ADDENDUM NO. 3

PROJECT: NEW FIRE STATION #27
COSA, San Antonio, TX

ARCHITECT: McCall & Associates-AIA-Architects
8610 N. New Braunfels, Suite 201
San Antonio, Texas 78217-6359
(210) 824-8400 (Office)
(210) 824-8484 (Fax)

DATE: November 5, 2010

PARTIAL ELEVATION - JOKER'S STAND (FROM THE APPARATUS BAY)

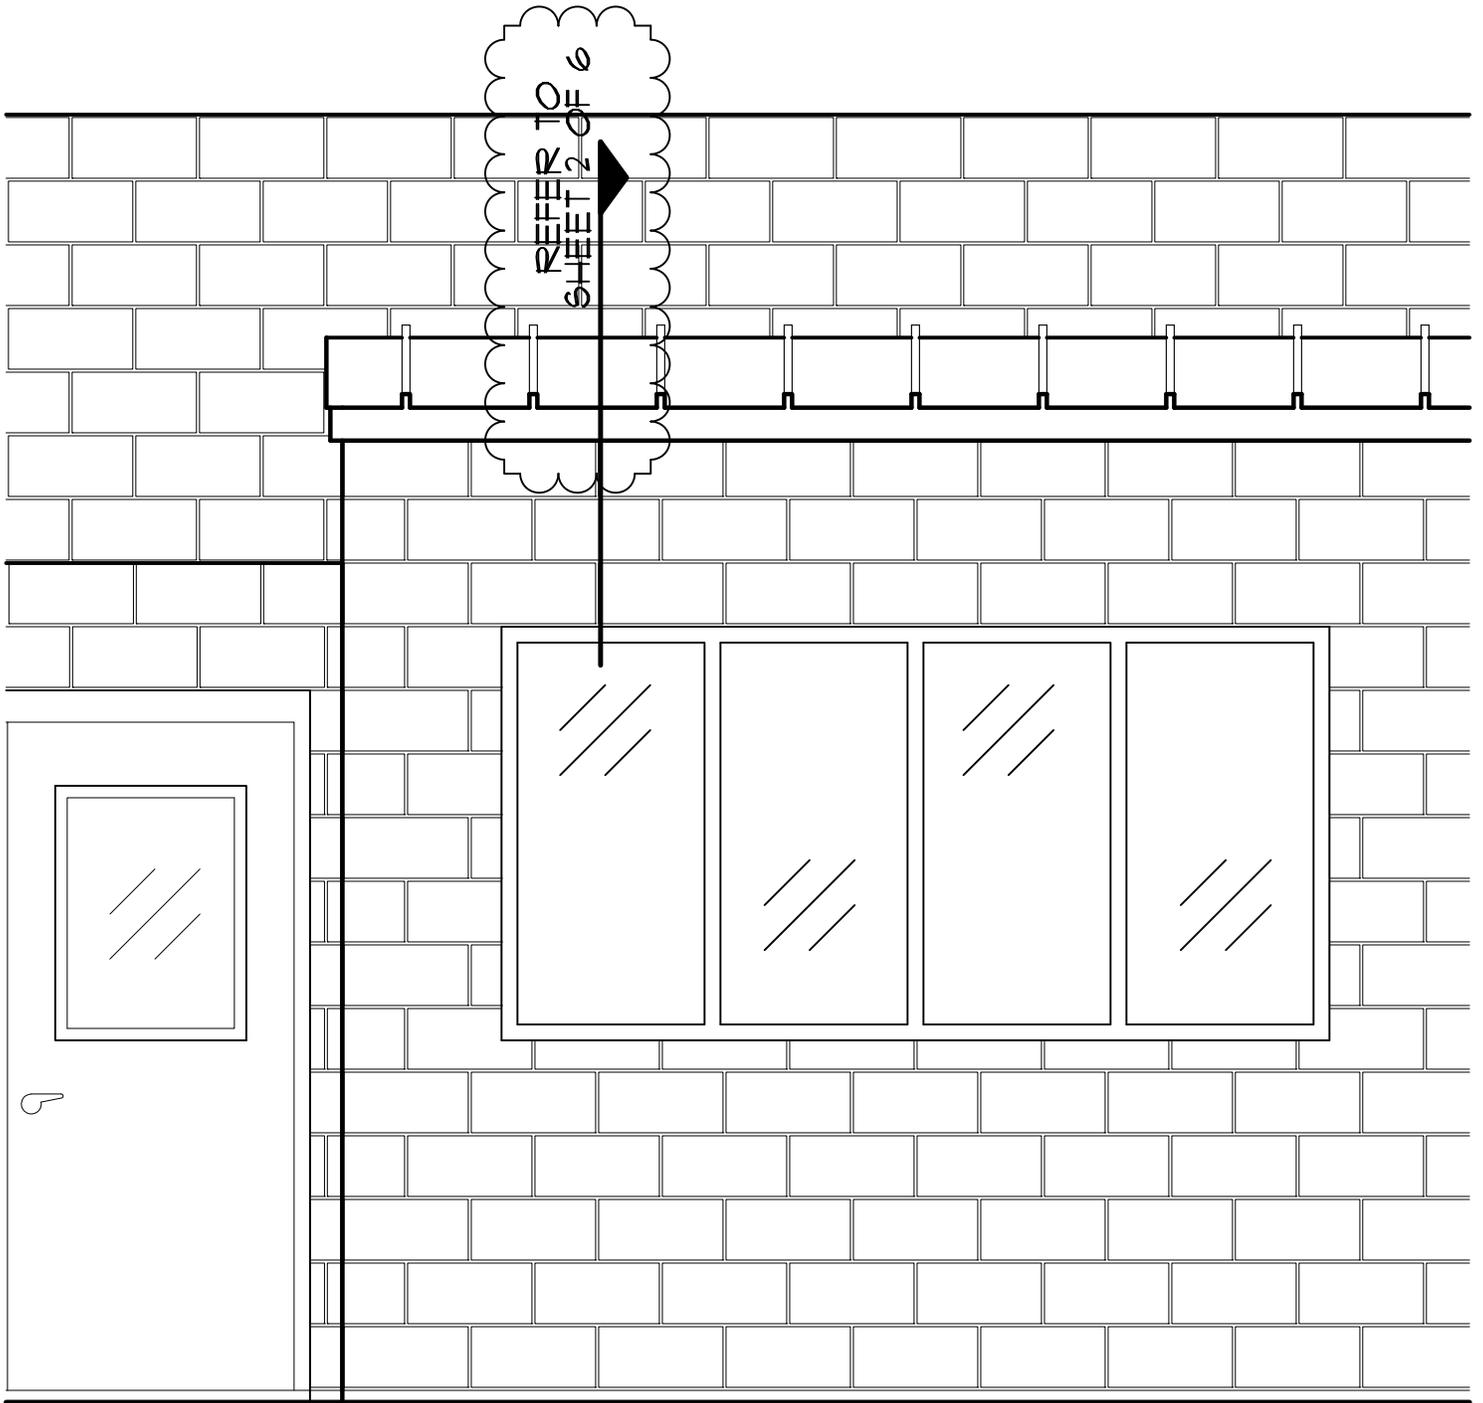
1. Graphical clarification has been provided for the fascia trim located at all interior standing seam metal roof conditions (interior shed roofs located in vehicle bays). Refer to ***Attachment "A"*** (sheets 1 thru 6) for additional and/or revised details that show this clarification. Finish floor height references are also indicated on ***Attachment "A"***.

ATTACHMENT OF FASCIA @ INTERIOR S.S. GALV. MTL. ROOFS, TYP.

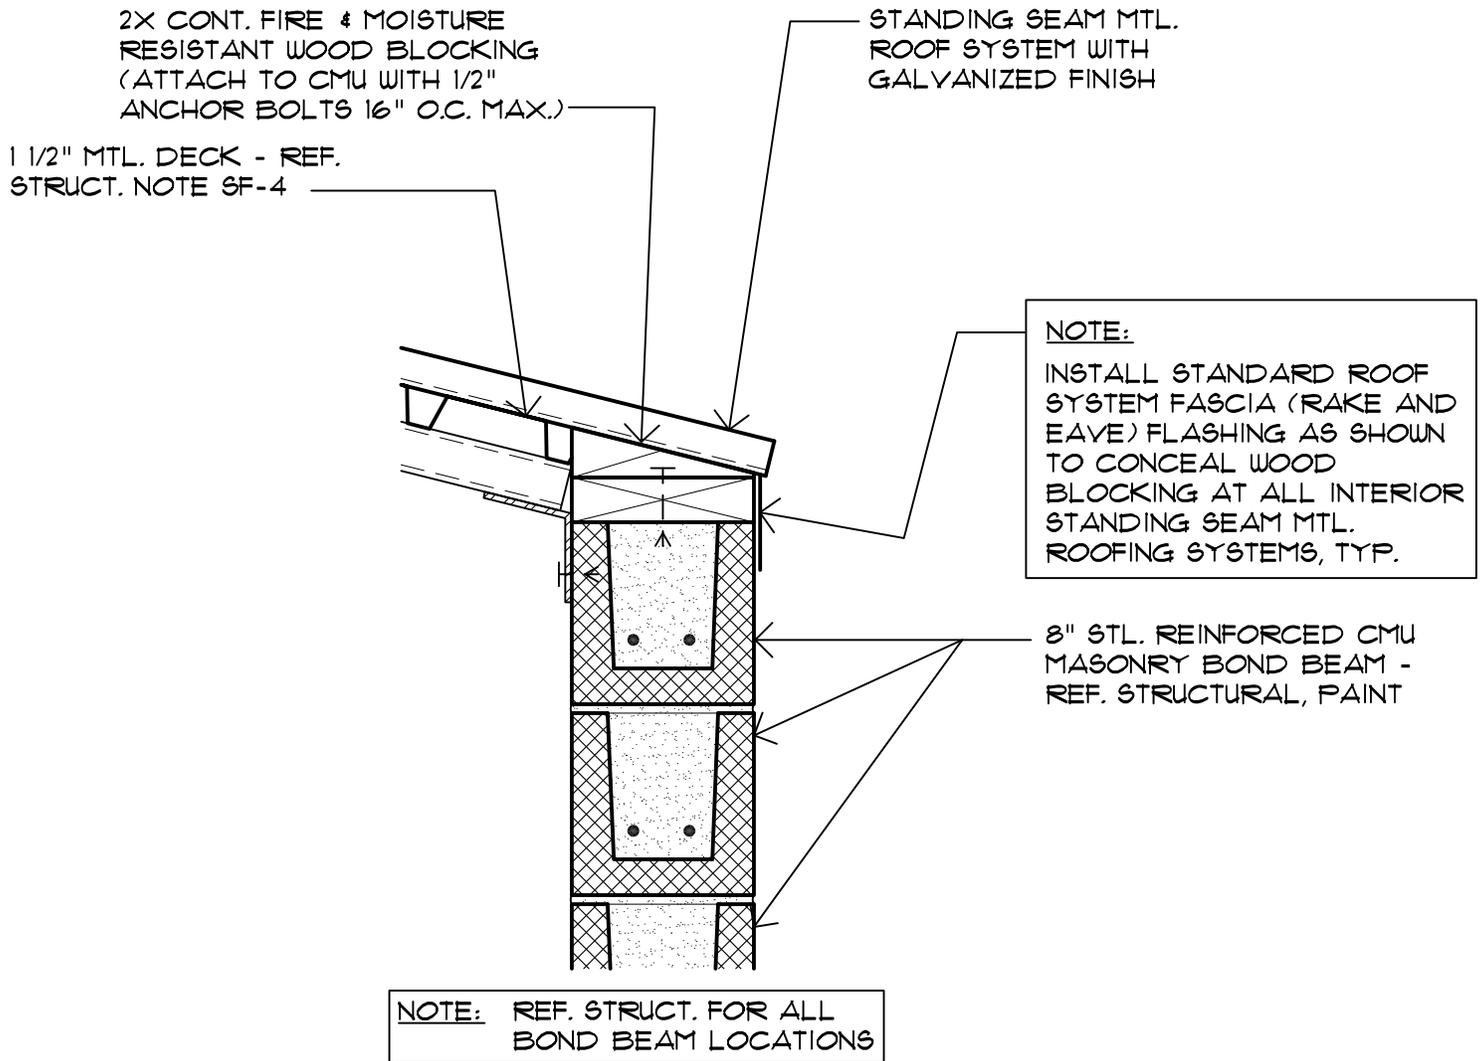
GRAPHICAL CLARIFICATION REGARDING THE FASCIA FOR THE FOLLOWING DETAILS:

**1/A11.3, 1/A11.4, 2/A11.4, 1/A11.5, 6/A14.11, 7/A14.15,
4/S4.7, 6/S4.7, 7/S4.7, 10/S4.7**

FRONT ENTRY TOWER LIGHT FIXTURE MOUNTING

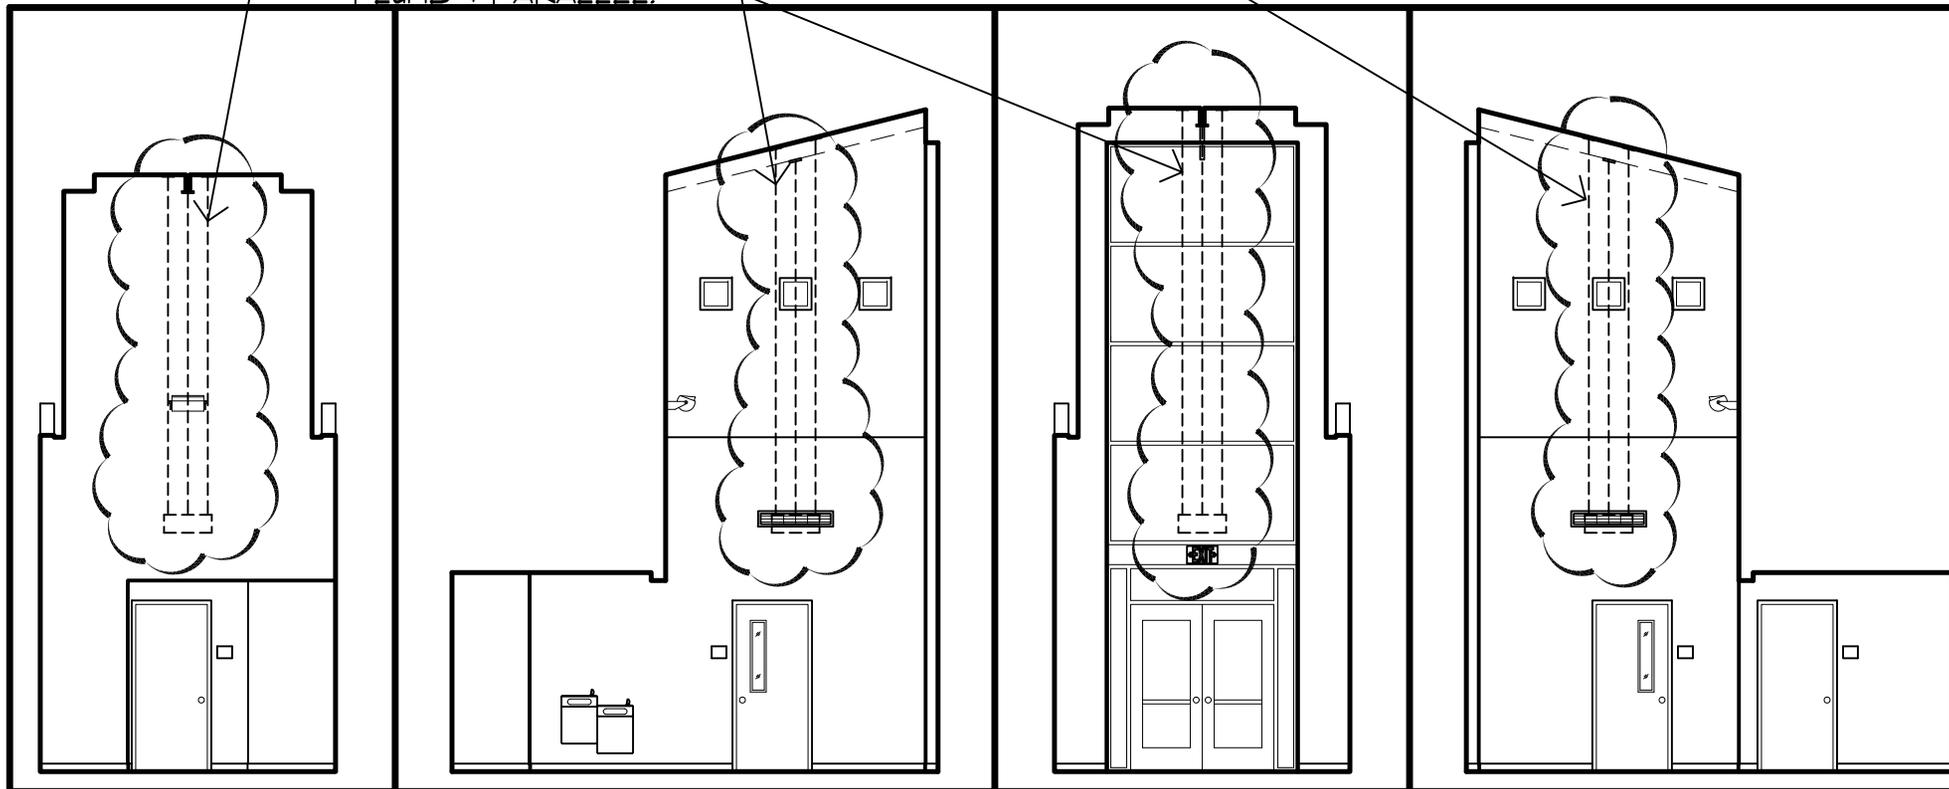
2. Graphical clarification has been provided for light fixture "Type FW". This pendant fixture, which is located in the Entry Tower, shall be hung from a multi-point mount in lieu of a central mount (no change is required to the electrical light fixture schedule as the fixture is already specified this way). Refer to ***Attachment "B"*** (sheet 1) for this clarification.

GRAPHIC CLARIFICATION:

FRONT ENTRY TOWER LIGHT FIXTURE (TYPE FW - REF. ELEC. LIGHT FIXTURE SCHEDULE) SHALL HANG FROM A MULTI-POINT MOUNT IN LIEU OF A CENTRAL MOUNT. ENSURE AIRCRAFT CABLES ARE INSTALLED EXACTLY PLUMB & PARALLEL.

ELEVATIONS: 2/A12.6, 3/A12.6, 4/A12.6, AND 5/A12.6

TYPICAL RAKE CONDITION

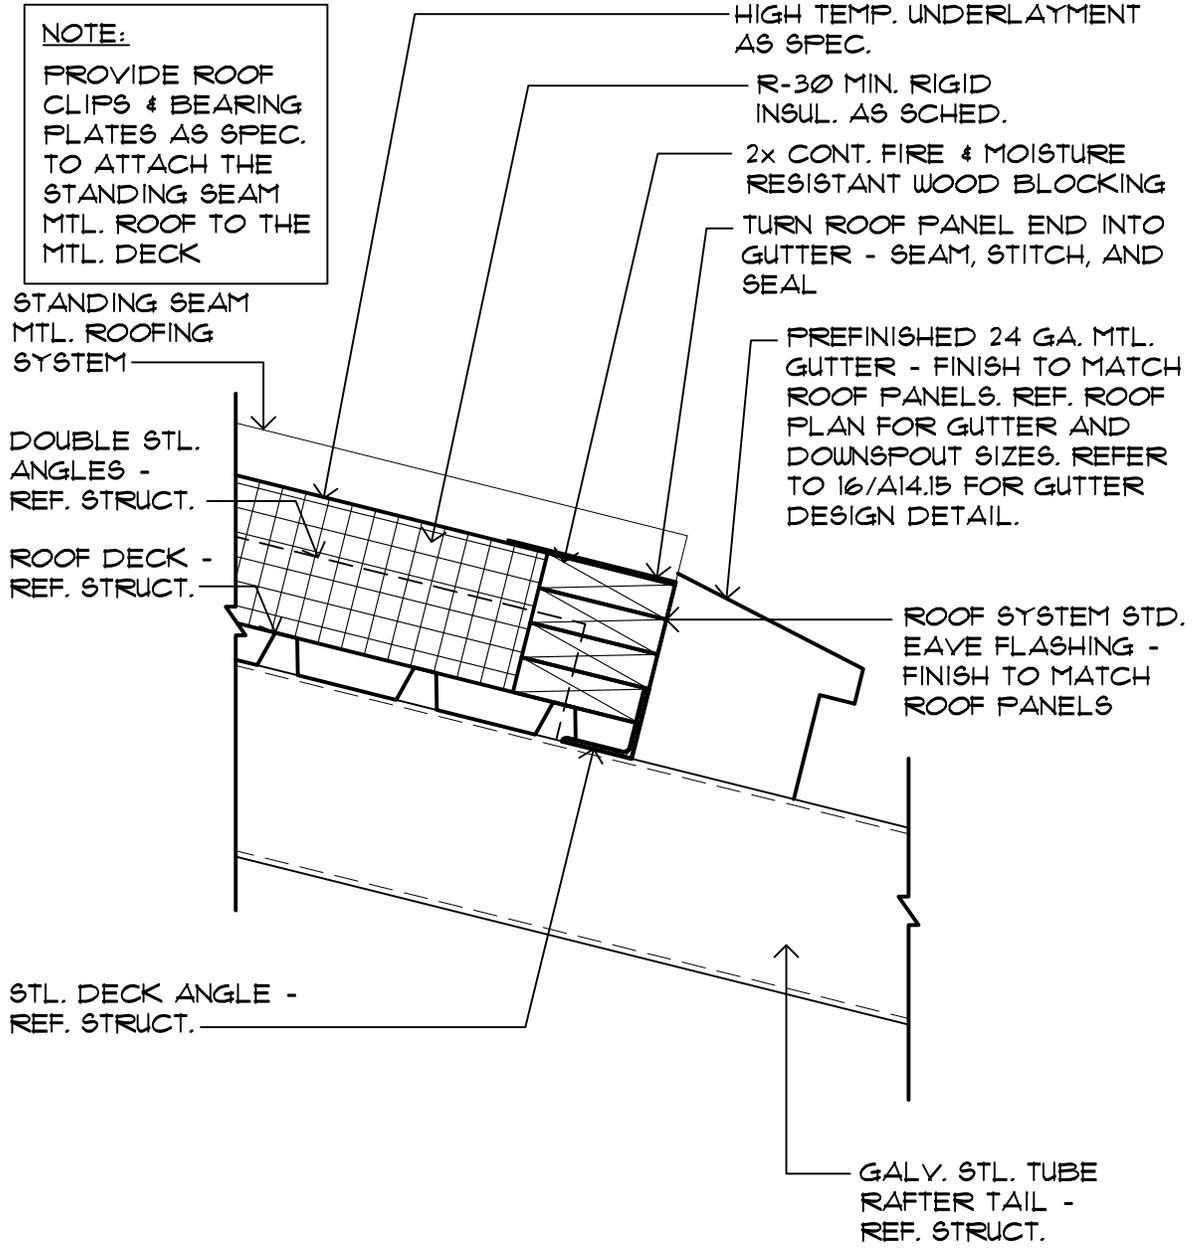
3. Notation has been provided on two details to note the "typical" roof conditions (both rake and eave) for the exterior roof. Refer to ***Attachment "C"*** (sheets 1 and 2) for this clarification.
